Work Order ID 93545

Item Name: Crosstube Turning Detail

DART AEROSPACE LTD	Work Order:	93545
Description: Crosstube Assembly (205/212/412 High Fwd)	Part Number:	D212-664-141
Inspection Dwg: D212-664-141 Rev: D		Page 1 of 2

DRAWING NO. D212-664-141	TITLE XTUBE ASSY (205/212/412 HI FWD)	REV. D	DART AEROSPACE LTD ENGINEERING ORDER		D.E.O. NO. D212-664-141-D-1	SHEET NO. SHEET 1 OF 2	SCALE NTS
DRAWN	CHECKED	MFG. APPR.	APPROVED	DE APPR.			
DATE 11.04.07	DATE 11.07.11	DATE 11.04.12	DATE 11/04/12	DATE 11.04.12

**D212-664-141/-141B
ASSEMBLY DETAIL**

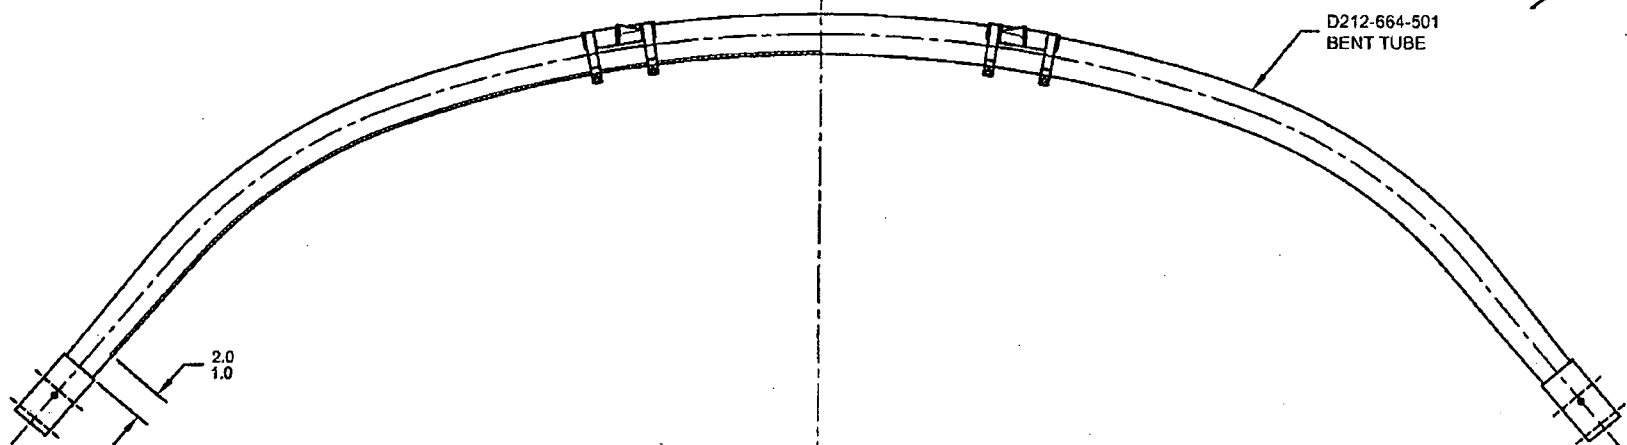
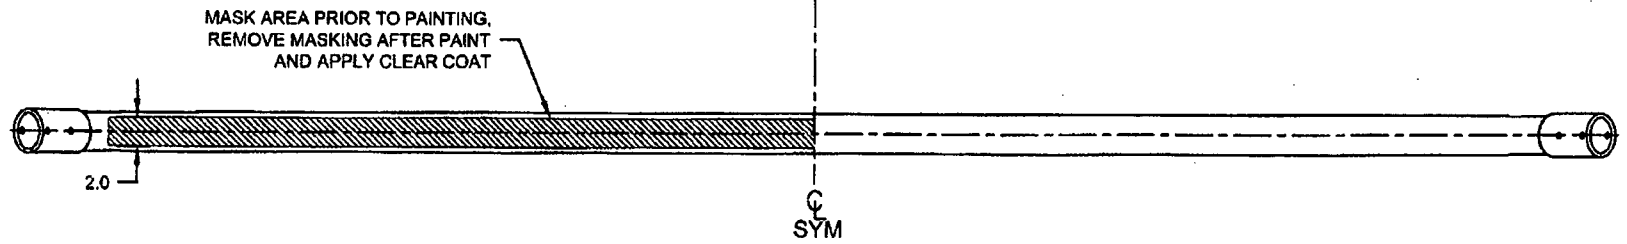
PURPOSE:

ADD AN INSPECTION WINDOW TO UNDERSIDE OF CROSSTUBE.

NOTES 2 OF SHEET 1 IS AMENDED AS FOLLOWS:

IS:

WAS:

- 2) FINISH: CHEMICAL CONVERSION COAT PER DART QSI 005 4.1
PRIME INSIDE AND OUTSIDE PER DART QSI 005 4.2
MASK UNDERSIDE OF CROSSTUBE AS SHOWN (HATCHED AREA) AND
PAINT OUTSIDE PER DART QSI 005 4.2
REMOVE MASKING AND APPLY CLEAR COAT

- 2) FINISH: CHEMICAL CONVERSION COAT PER DART QSI 005 4.1
PRIME INSIDE AND OUTSIDE PER DART QSI 005 4.2
PAINT OUTSIDE PER DART QSI 005 4.2
